RENESAS TECHNICAL UPDATE

Product Category	MPU/MCU		Document No.	TN-RL*-A0147A/E	Rev.	1.00
Title	Correction for Incorrect Description Notice Descriptions of errors in the RL78/F23, F24 User's Manual: Hardware Rev.1.10		Information Category	Technical Notification		
Applicable Product	RL78/F23, F24 Group	Lot No.	Reference Document	RL78/F23, F24 User's Manual: Hardware Rev.1.10 (R01UH0944EJ0110)		
		All lots

This document describes misstatements found in RL78/F23, F24 User's Manual: Hardware Rev.1.10 (R01UH0944EJ0110).

● **18.12.1, Figure 18–45: Correction of typo in TMSTSm.TMTRF[1:0] bit in figure.**

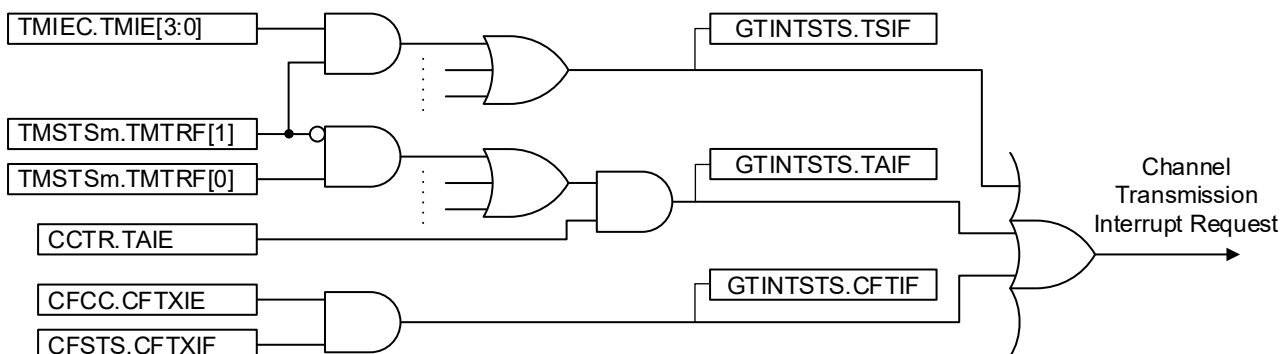
(Incorrect) Generate from TMSTSm.TMTRF[0] to GTINTSTS.TSIF.

(Correct) Generate from TMSTSm.TMTRF[1] to GTINTSTS.TSIF.

Figure 23-10. Example of Settings for SNOOZE Mode Status Output

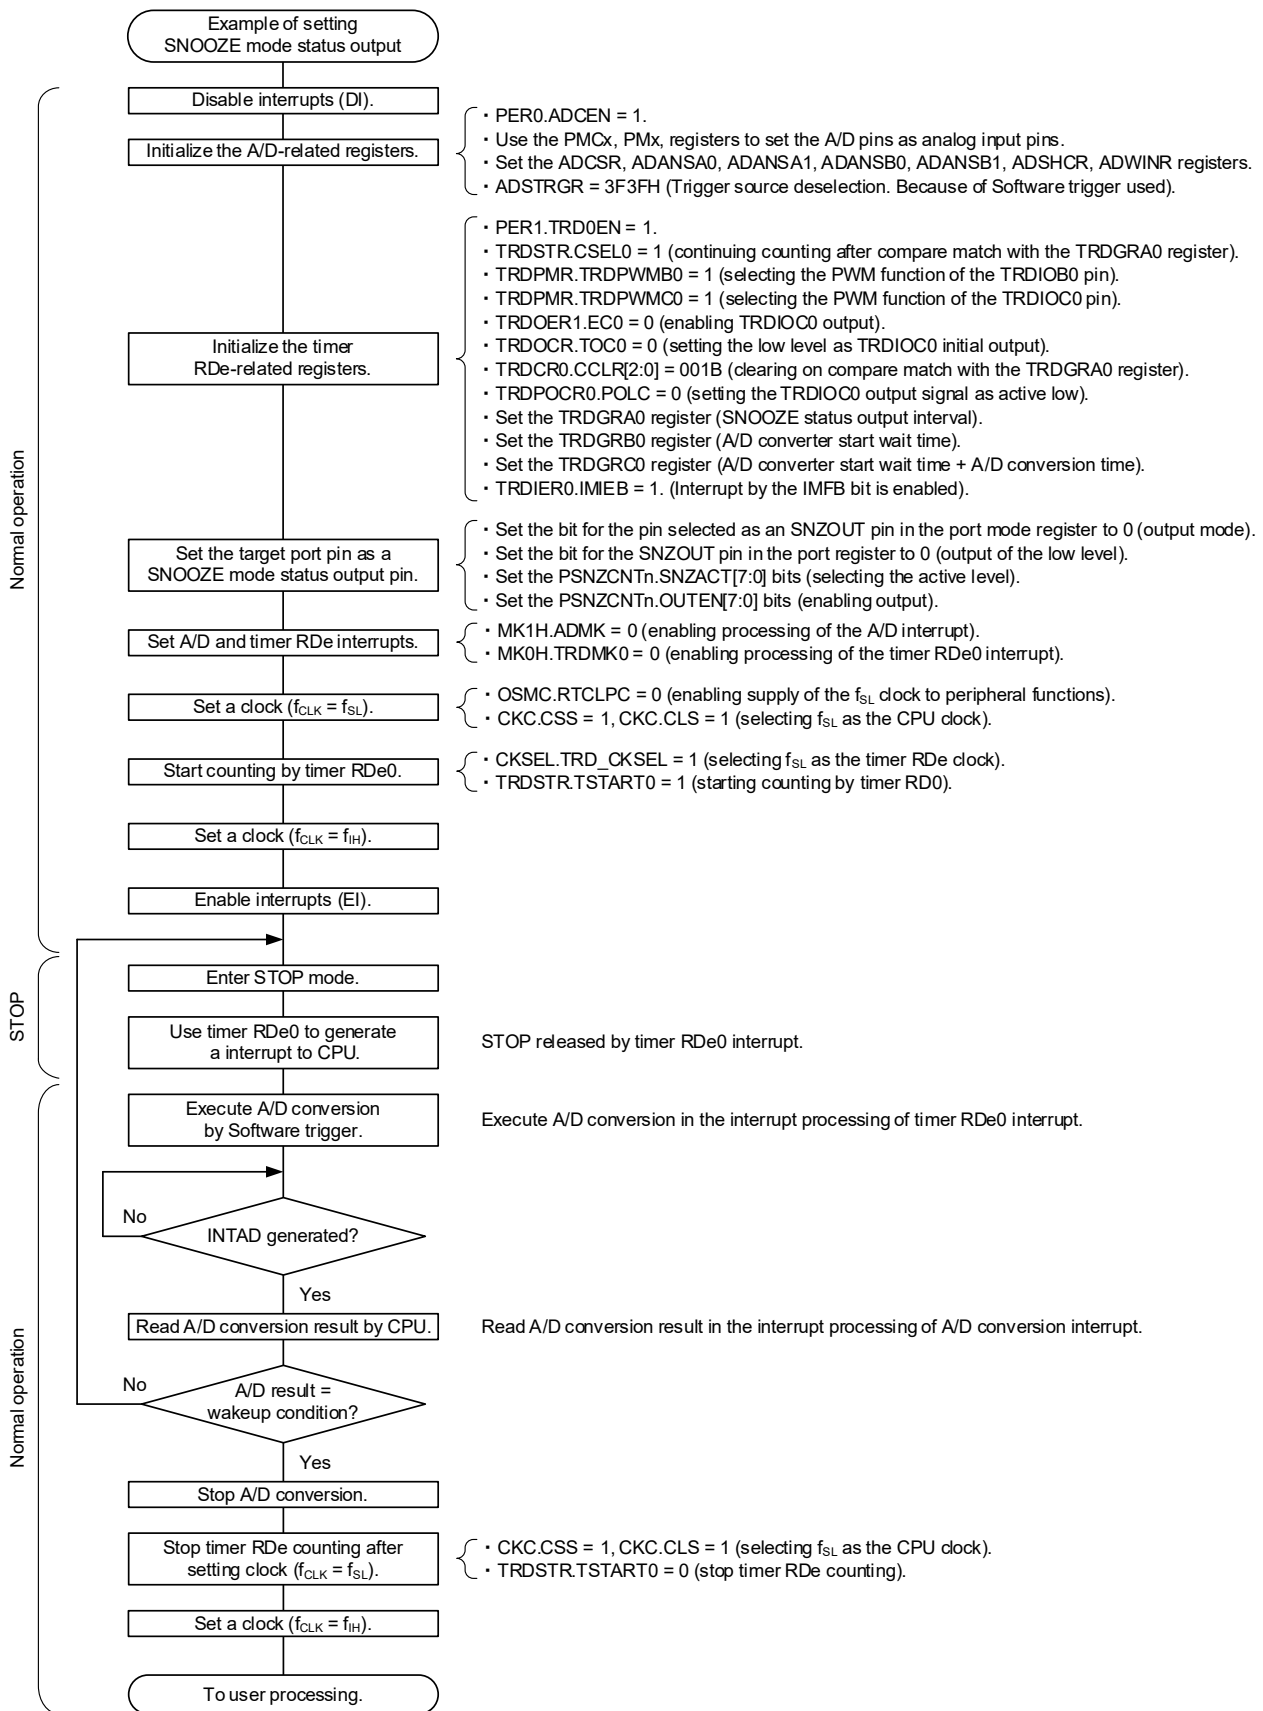
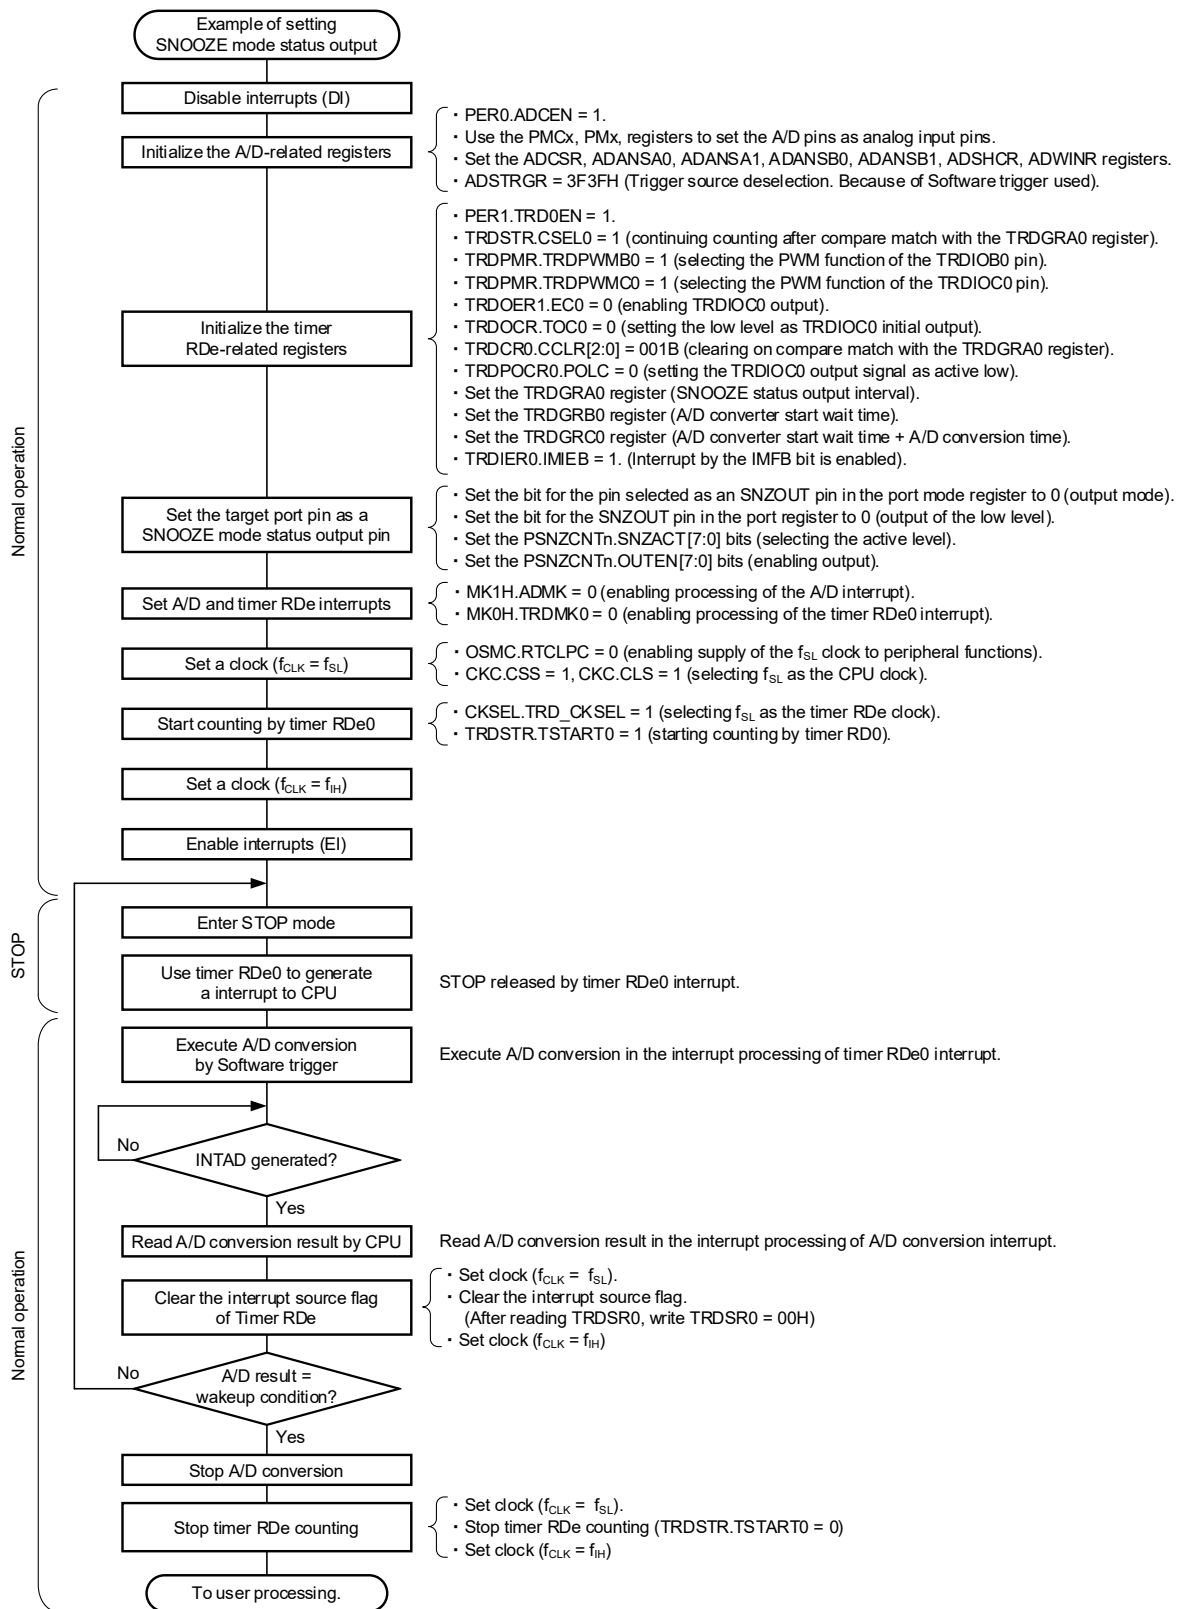
No.4: Correction of typo in Example of Settings for SNOOZE Mode Status Output

(Correct) Add clearing process for interrupt source flag.

Figure 32-8. Flow of Self-Programming (Rewriting Flash Memory)

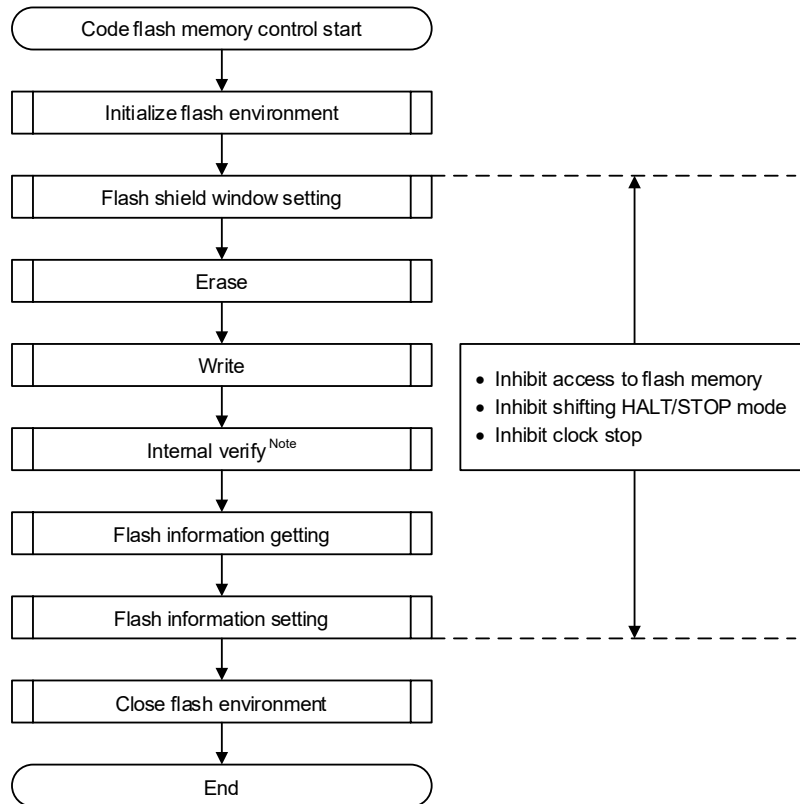
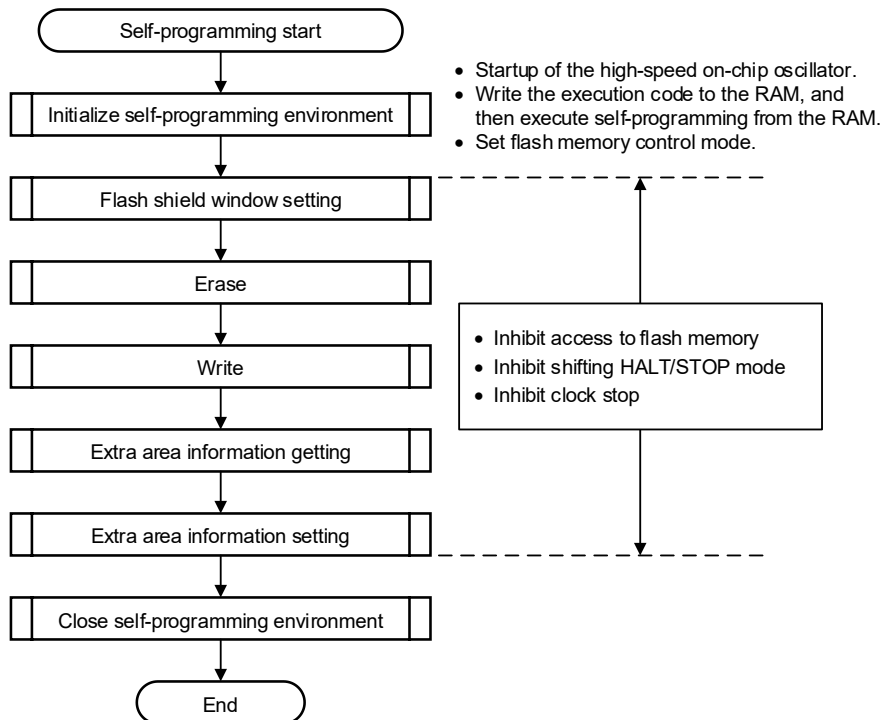
● 32.7.1, Correction of typo in Figure 32-8.

39.1 32-pin Products

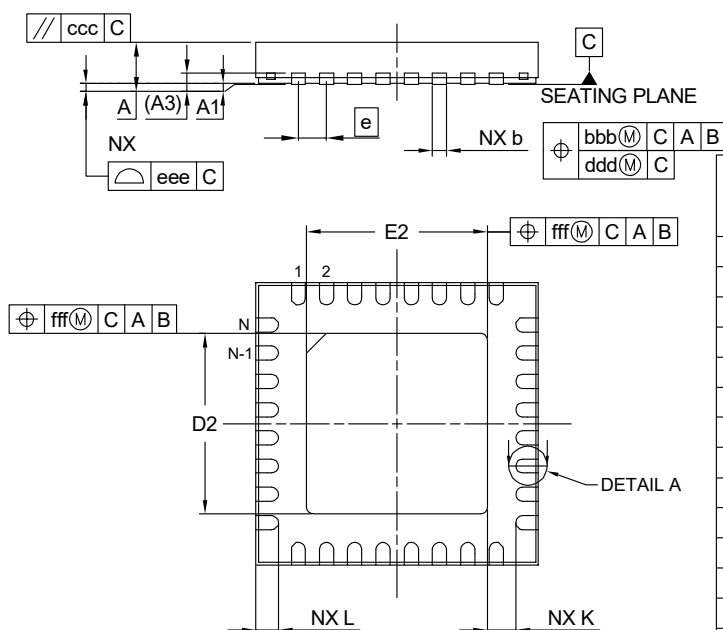
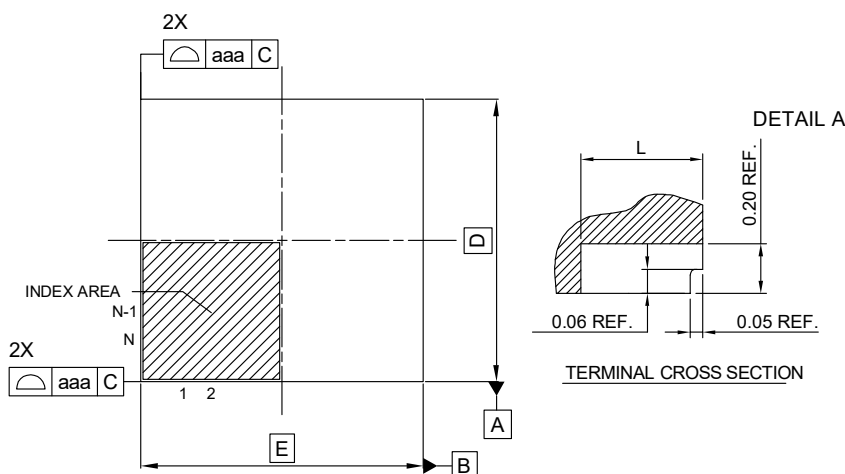
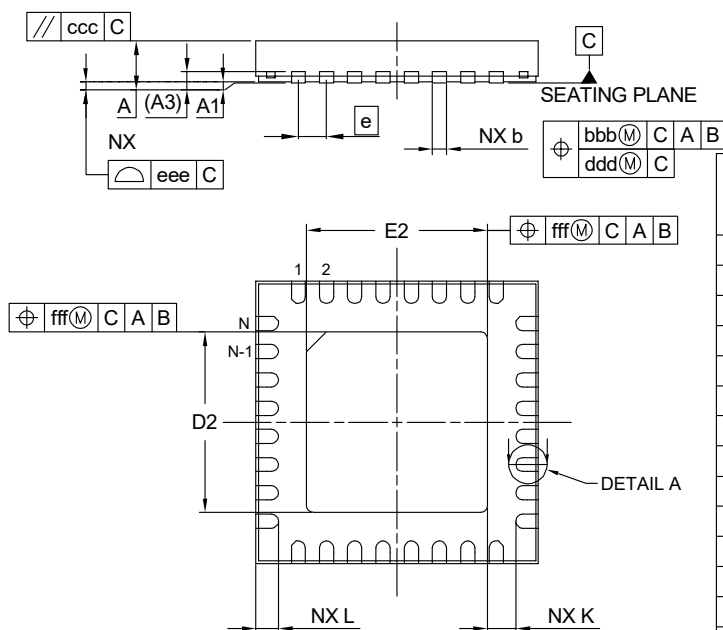
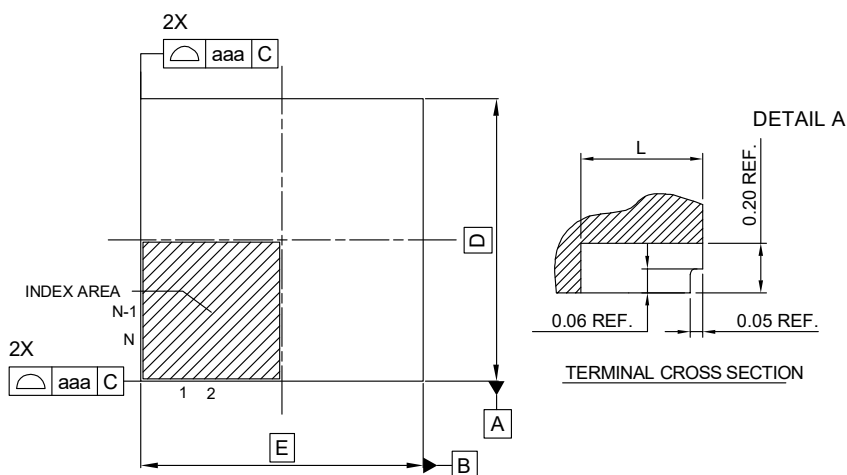
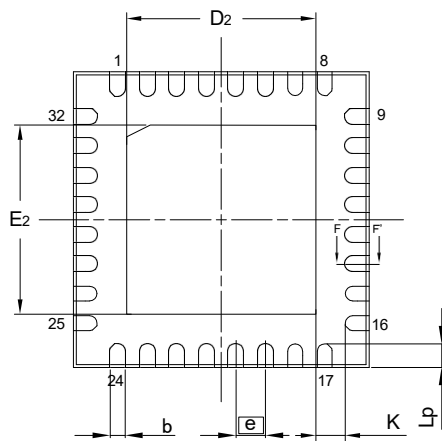
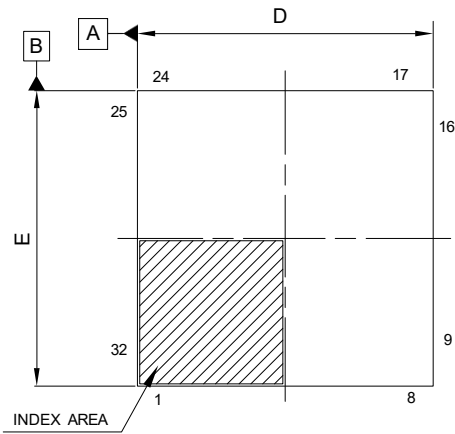
No.10: Add description of package drawing (32-pin product)

There are two types of package drawings. You can check which package drawing used by product marking. Please refer to the product packaging information on Renesas website for more information.
